**DOCKET 50-255 - LICENSE DPR-20 - PALISADES PLANT
TECHNICAL SPECIFICATION CHANGE REQUEST
SPENT FUEL POOL BORON CONCENTRATION**

TECHNICAL SPECIFICATION CHANGE REQUEST
SPENT FUEL POOL BORON CONCENTRATION

**ENCLOSURE 1
REQUEST FOR CHANGE TO THE TECHNICAL SPECIFICATIONS
SPENT FUEL POOL BORON CONCENTRATION**

**SPENT FUEL POOL BORON CONCENTRATION
EXISTING PAGES MARKED TO SHOW PROPOSED CHANGES**

Figure 4.3-1 (page 1 of 1)
New Fuel Storage Rack Arrangement

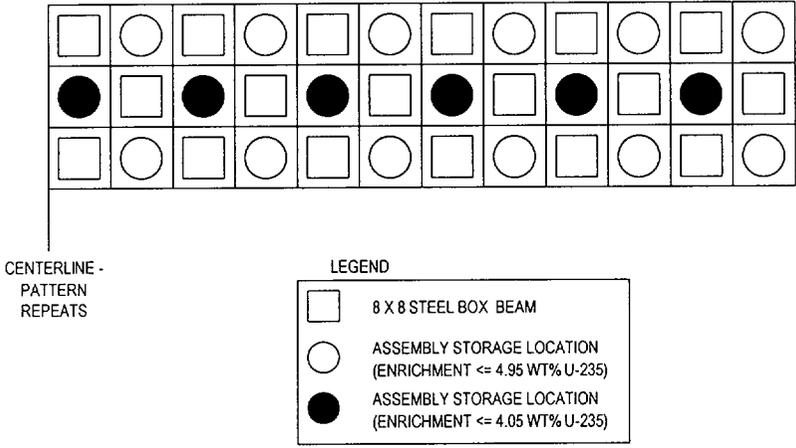
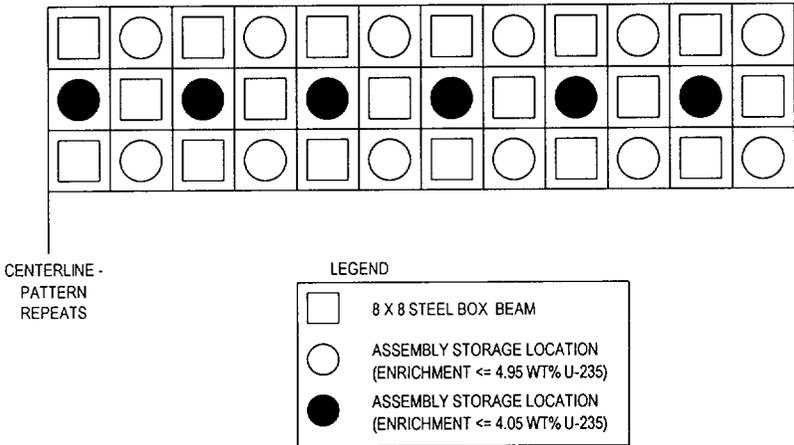
“Twenty-four unirradiated fuel assemblies having a maximum planar average U-235 enrichment of 4.95 weight percent, and stored in accordance with the pattern shown in Figure 4.3.-1, or

Thirty-six unirradiated fuel assemblies having a maximum planar average U-235 enrichment of 4.05 weight percent, and stored in accordance with the pattern shown in Figure. 4.3.-1.”

8. Delete existing Specification 4.3.1.3.c
9. Renumber existing Specification 4.3.1.3d to 4.3.1.3c
10. Add a new figure, Figure 4.3-1; Figure 3 from EA-SFP-99-03.

- 4.3.1.3 The new fuel storage racks are designed and shall be maintained with:
- a. Twenty four unirradiated fuel assemblies having a maximum planar average U-235 enrichment of 4.95 weight percent, and stored in accordance with the pattern shown in Figure 4.3-1, or

Thirty six unirradiated fuel assemblies having a maximum planar average U-235 enrichment of 4.05 weight percent, and stored in accordance with the pattern shown in Figure 4.3-1;
 - b. $K_{\text{eff}} \leq 0.95$ when flooded with either full density or low density (optimum moderation) water including allowances for uncertainties as described in Section 9.11 of the FSAR.

Figure 3 Palisades New Fuel Storage Rack Loading Patterns.

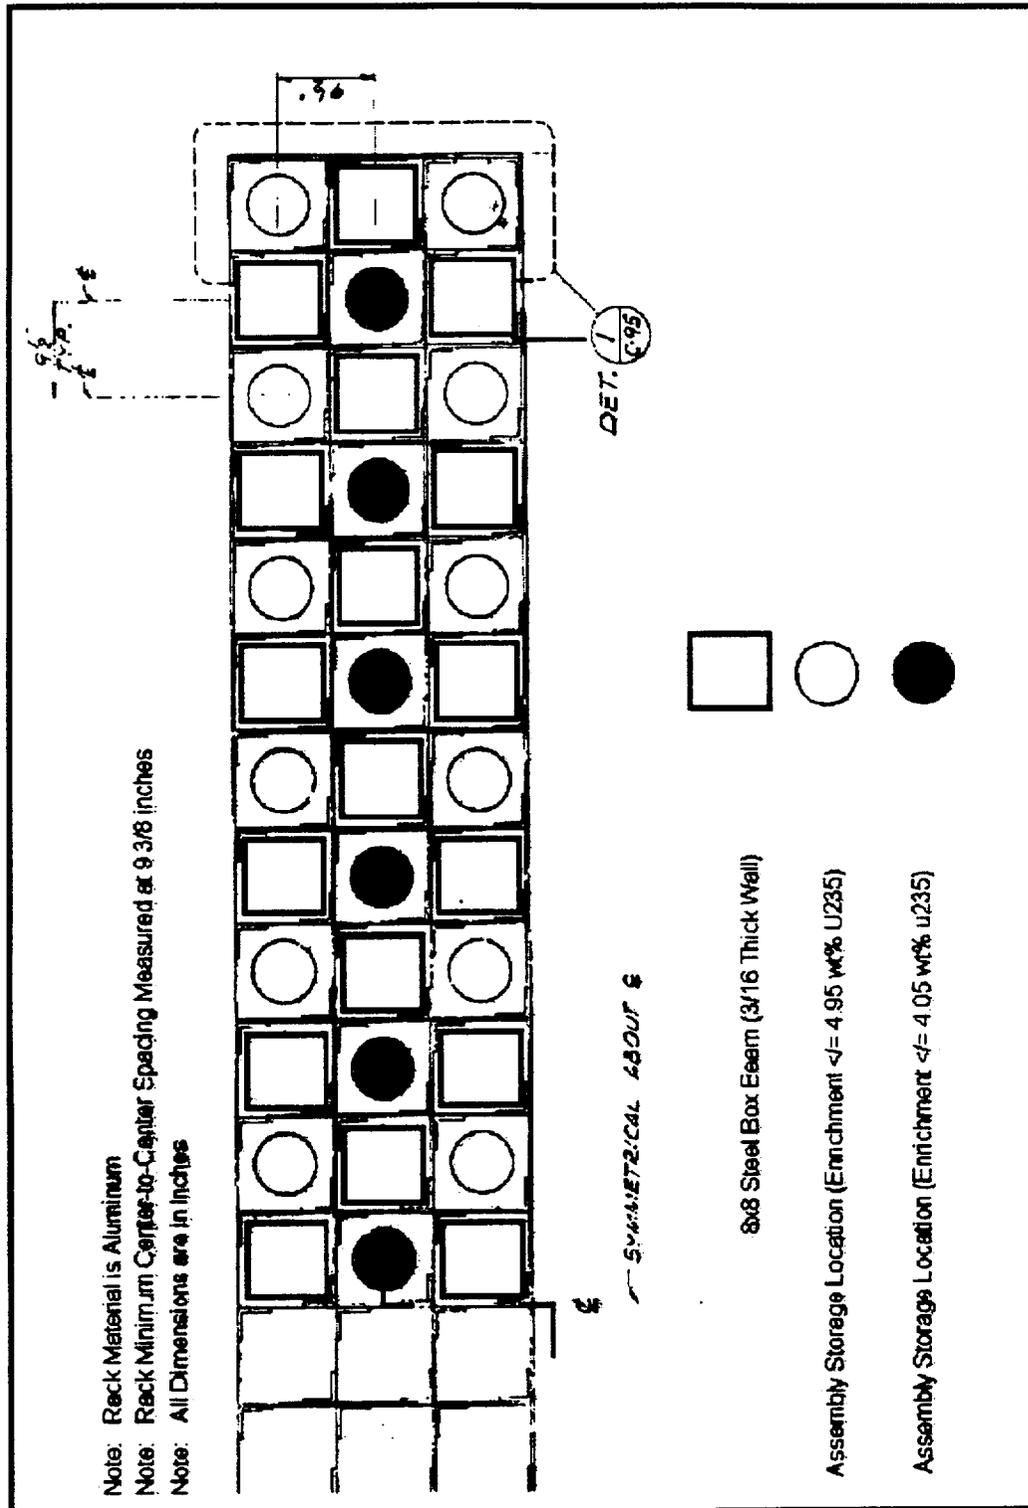
or twenty-four 4.95 wt% assemblies [17]. A specific loading pattern is assumed for each enrichment level (i.e. enrichments ≤ 4.05 wt% and enrichments > 4.05 wt% up to 4.95 wt%) as shown in Figure 3. The loading patterns are relatively easy to interpret. Specifically, if any assembly loaded in the new fuel storage rack has a maximum planar average enrichment greater than 4.05 wt%, then no fuel can be loaded into the center row of the rack. The box beams and core plugs remain located in alternating positions regardless of the fuel loading pattern.

Figure 9 Region II Burnup Curves.

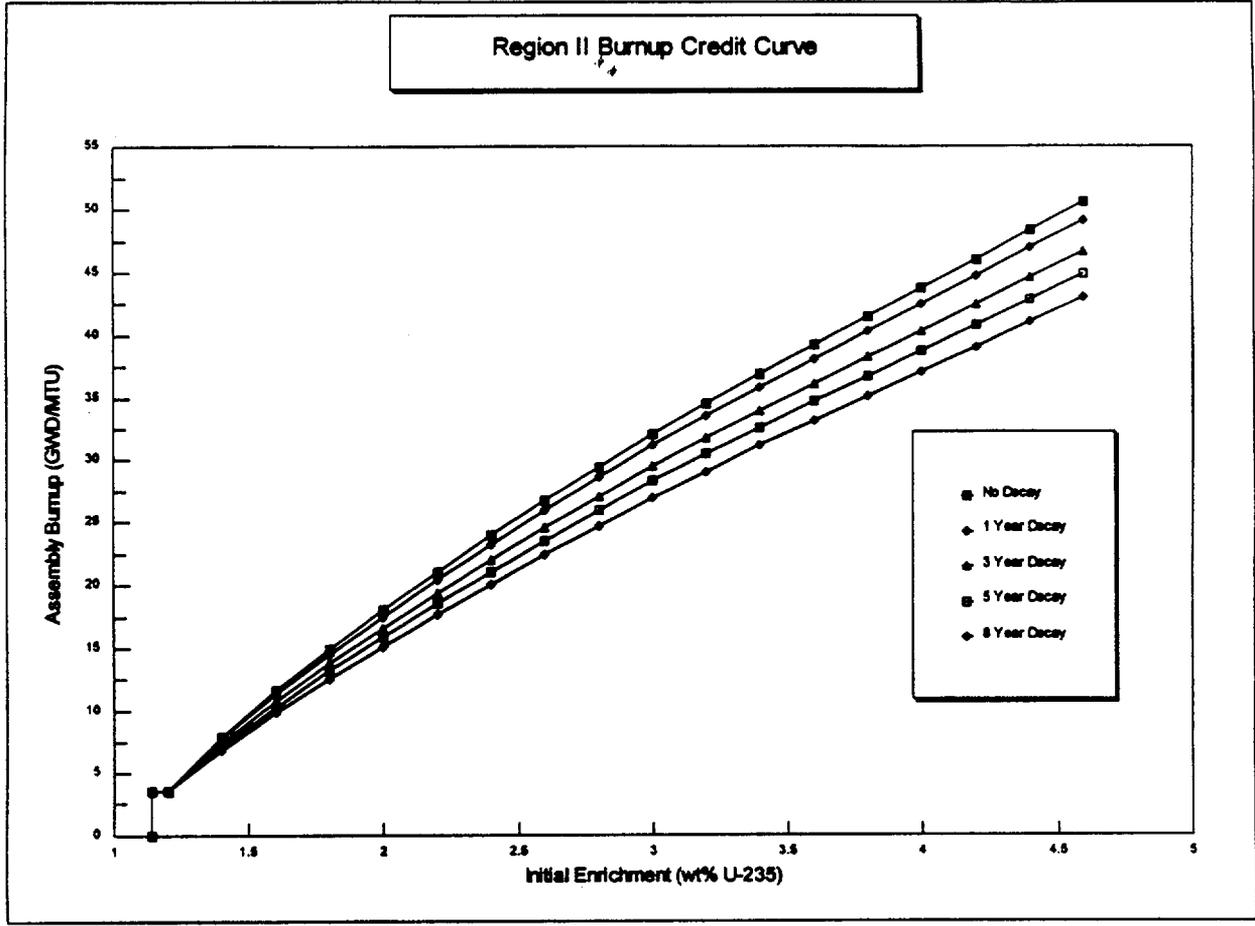
3. Replace Table 3.7.16-1 with Table 4 from EA-SFP-99-03.

The curves presented in Figure 9 are used to determine the eligibility of assemblies for storage in the Region II racks. They are developed to ensure that $k_{95/95-No Boron}$ remains below 1.0 (subcritical). Assemblies are classified by their maximum average planar initial enrichment in wt% ^{235}U . If an assembly has an average

Table 4 provides the data used to create Figure 9. It is acceptable to linearly interpolate between points to determine the required burnup for assemblies with initial enrichments not explicitly stated [33]. In addition, consideration of a 10% uncertainty in assembly burnup records is accounted for in the development of $k_{95/95-850\text{ppm}}$. It is therefore, NOT necessary to reduce stated burnup by a measurement uncertainty up to 10% when evaluating an assembly against the curves.
